# Final Drainage Report

## High Forest Estates Subdivision Filing No. 1

Project No. 61188

May 3, 2023

MVE PROJECT 61188  
MVE DRAWING DRAIN-EX

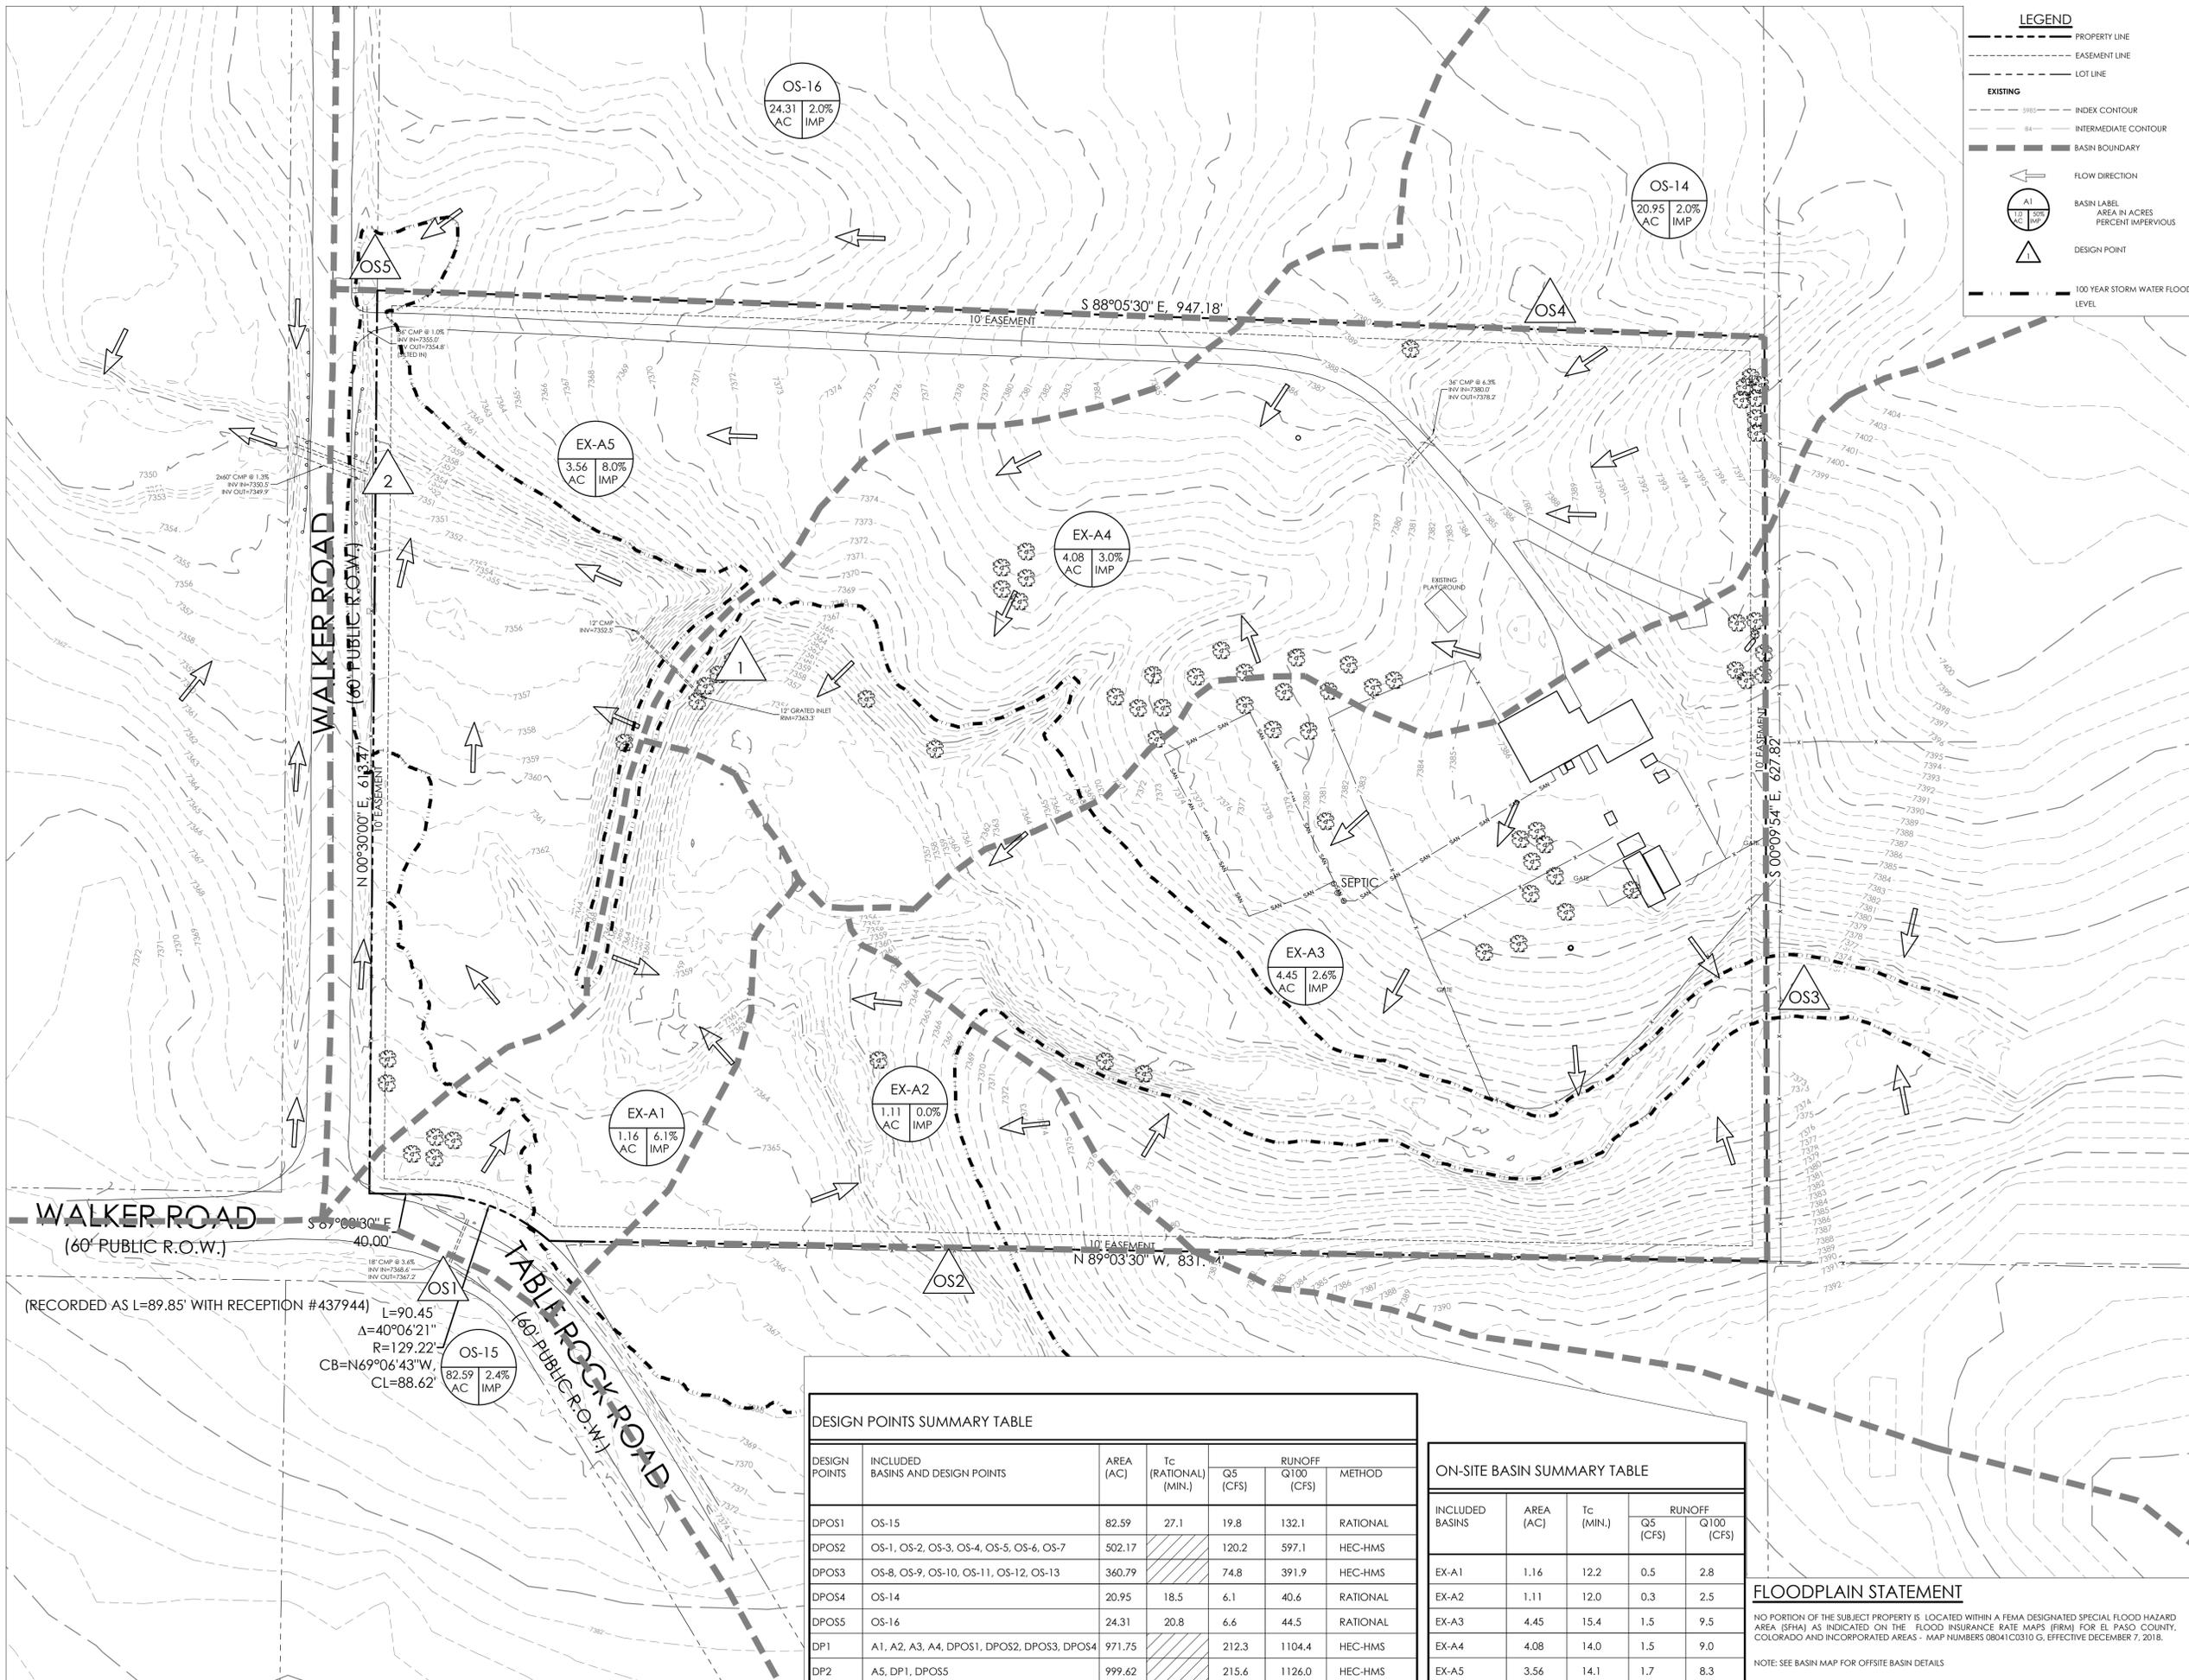
Per ECM 3.2.4 developed flows have to exit at a suitable outfall. Revise to include in the narrative the condition of the culverts and whether they can handle additional flows. Provide an analysis of the culverts.

MVE PROJECT 61188  
 MVE DRAWING DRAIN-PP

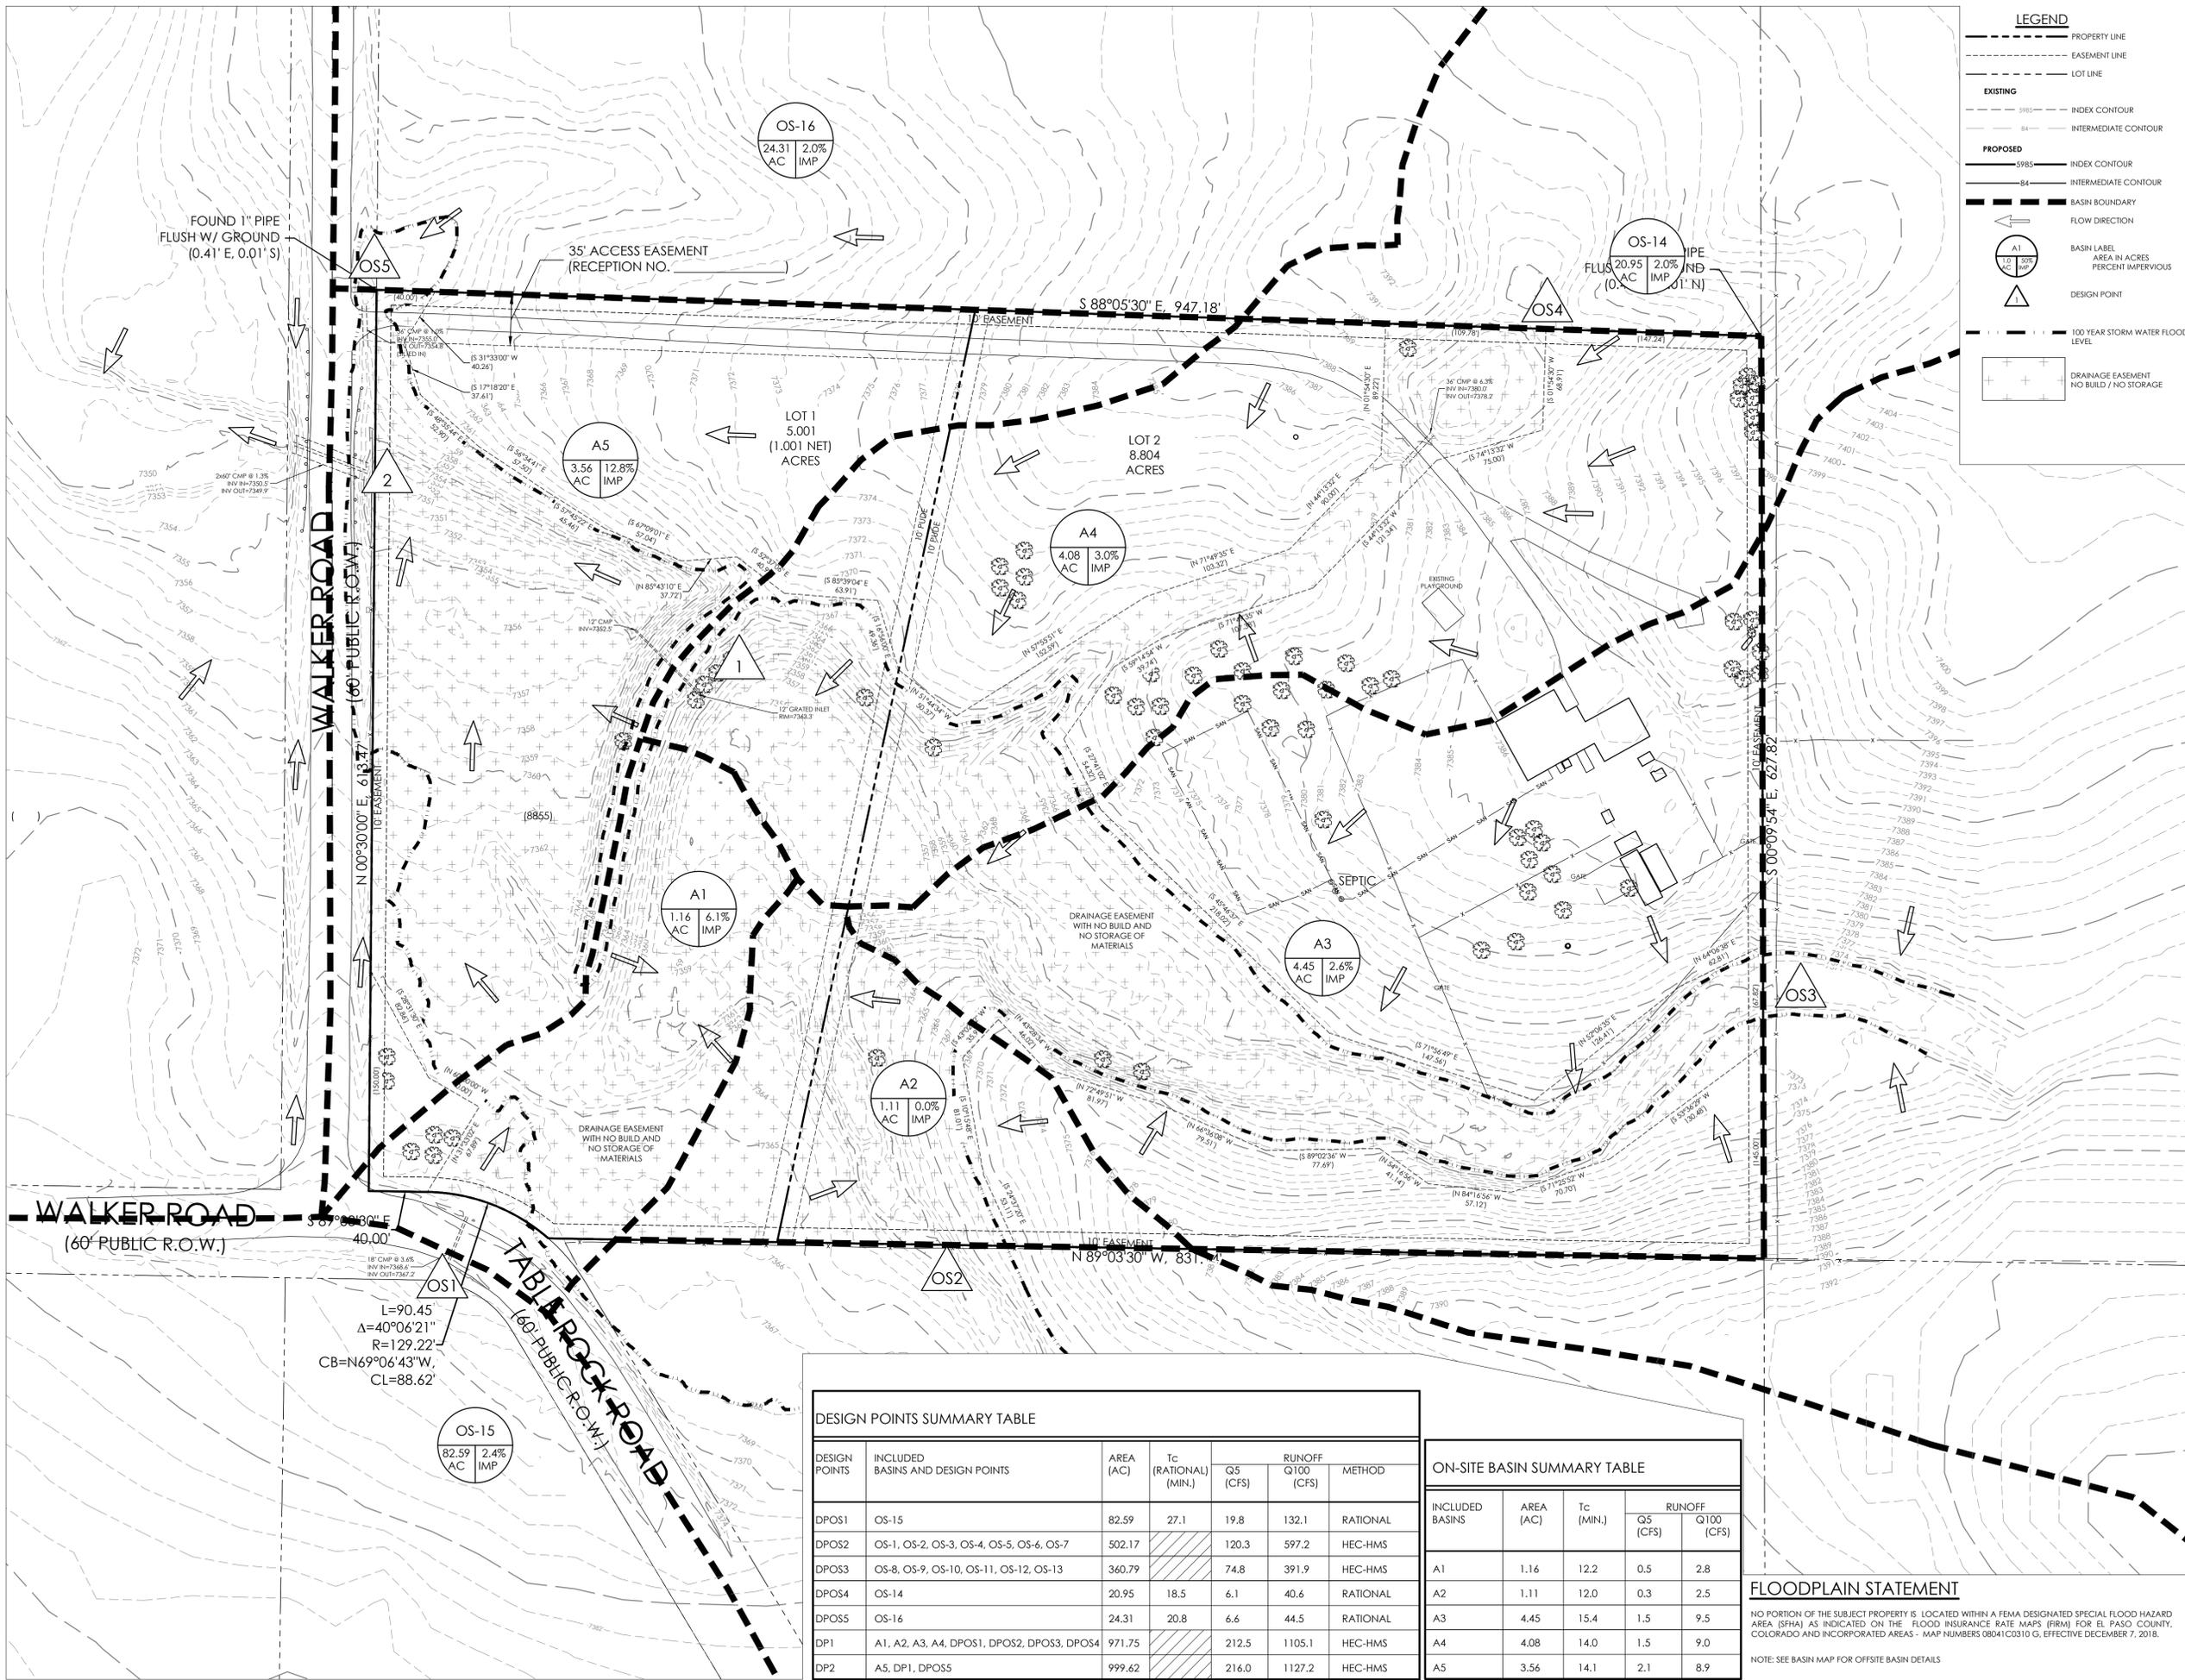
Provide correspondence from State Dam Engineer's office to determine whether this embankment is jurisdictional or not. If applicant does not have rights to have embankment they might require it to be removed.
